Access Compliance Report

Public Rights-of-Way

(Curb Ramps)

Intersection ID: 48161	Main Street: HEWITT_ASSOCIATES_DR	Cross Street: IBM_DR	Location:	E
ADA ID: A6906E1DF424	Ramp Type: Perp	Initial Pass/Fail: Fail	Overall Compliance: No	Severity Score: 8.75

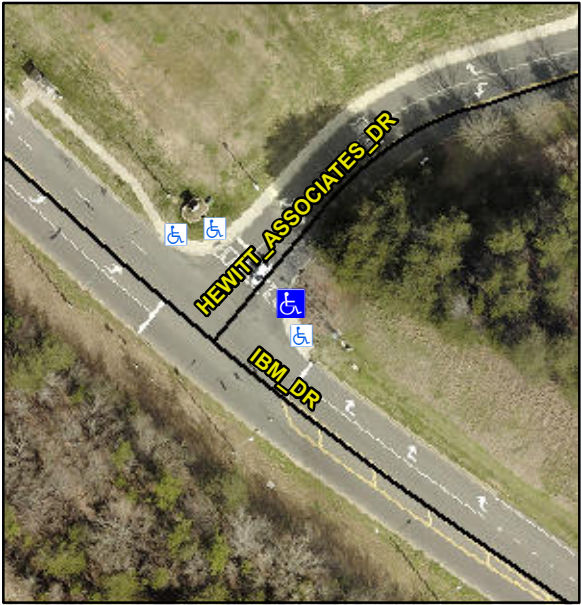
Codes/Mitigation Info/Possible Solution			Field Measurements/Component Compliance		
	Possible Solutions:		Compliance	Description	Data
	Remove & Replace Entire Ramp.		N/A	Ramp Length (in)	61.0
			No	Ramp Width (in)	47.0
			N/A	Flare Type LT	N/A
			N/A	Flare Slope LT (%)	N/A
			N/A	Flare Traversable LT?	N/A
			N/A	Landing Length (in)	N/A
			N/A	Landing Width (in)	N/A
			N/A	Landing Slope (%)	N/A
			N/A	Landing X Slope (%)	N/A
Surveyor Notes: N/A PROW/ADA: Not Found, R304.5.1			N/A	Flare Type RT	N/A
			N/A	Flare Slope RT (%)	N/A
			N/A	Flare Traversable RT?	N/A
			N/A	DWS Provided?	N/A
			N/A	DWS Contrast?	N/A
			N/A	DWS Length (in)	N/A
			N/A	DWS Full Width?	N/A
			N/A	DWS Offset (in)	N/A
			N/A	Shared Landing?	N/A
			N/A	Gutter Ponding?	N/A
			N/A	Gutter Lip Ht (in)	N/A
			N/A	Painted X Walk1?	Yes
				X Walk 1 Direction	To NW
			N/A	X Walk 1 Width (in)	87.0
				X Walk 1 Slope (%)	1.1
				X Walk 1 X Slope (%)	1.0
			N/A	Ramp inside XWalk1?	Yes
